ITEM B7
HPO File #: HP2026-0124

805 Cortlandt Street
Houston Heights South

Proposal: **Alteration Addition**, the applicant is proposing the following:

Recommendation: Approval

Side Setbacks (Addition and New Construction)

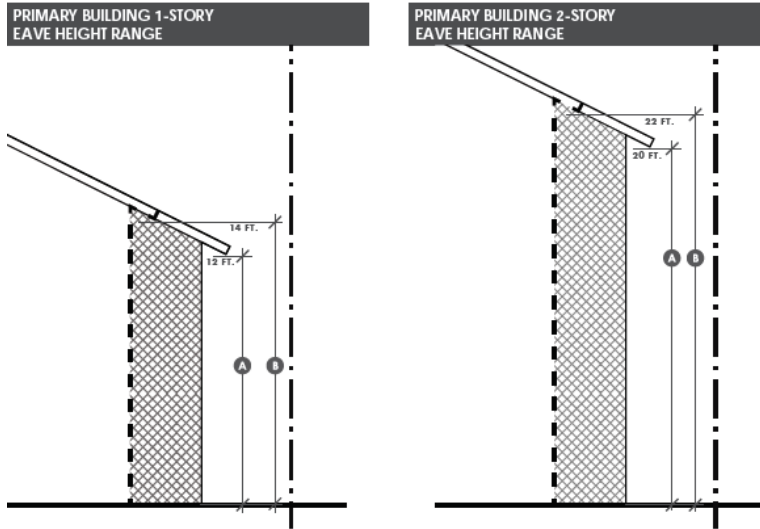
Proposed side setback (1): 5'-3"

Proposed side setback (2): 27'-1/2"

Detached Garage Ridge Height (New Construction)

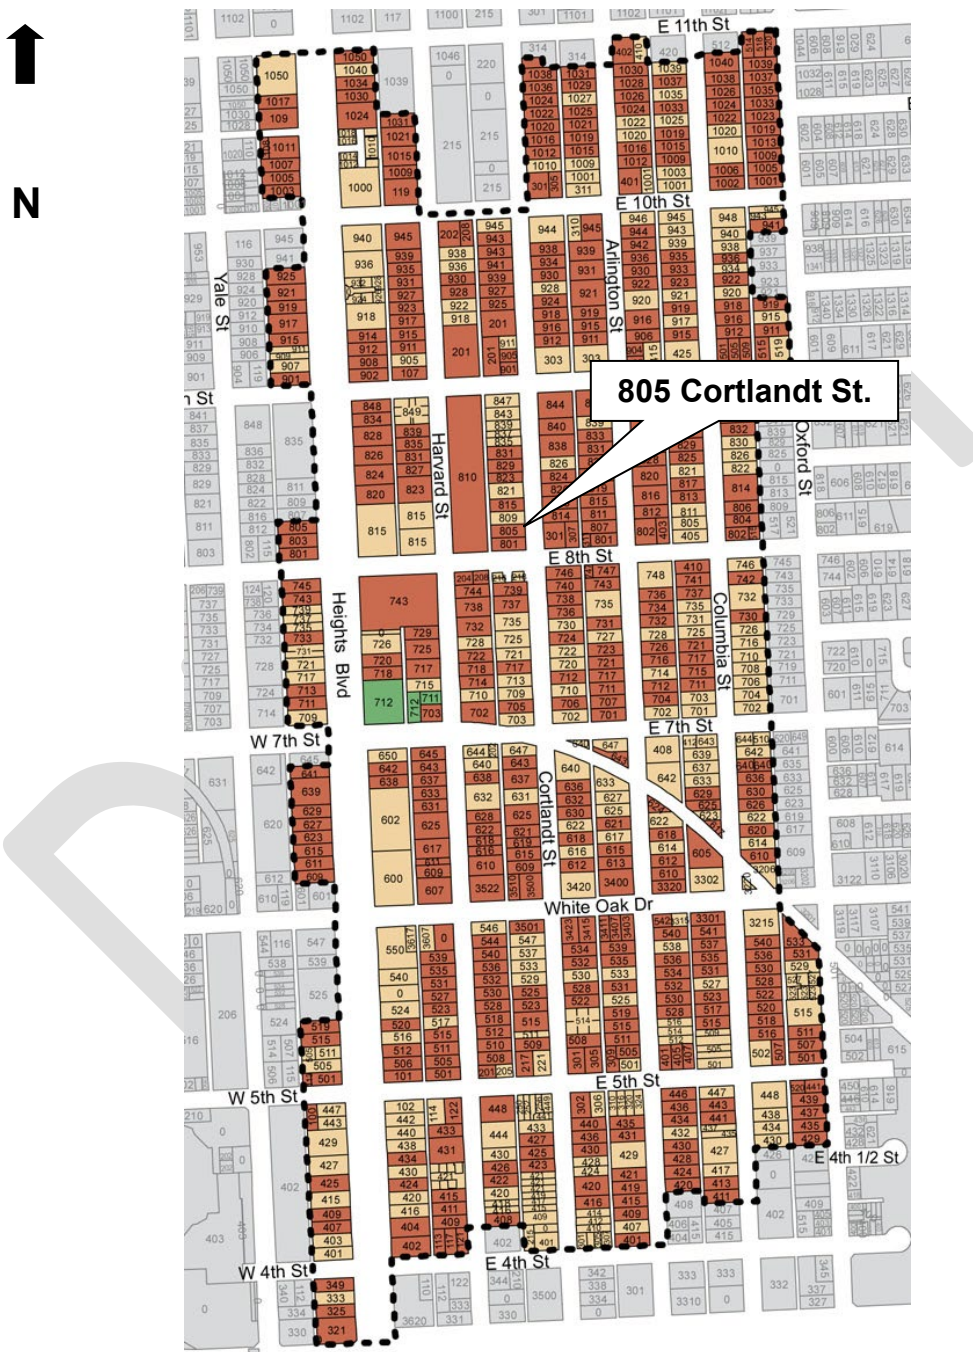
Proposed ridge height: 25'-6 1/2"
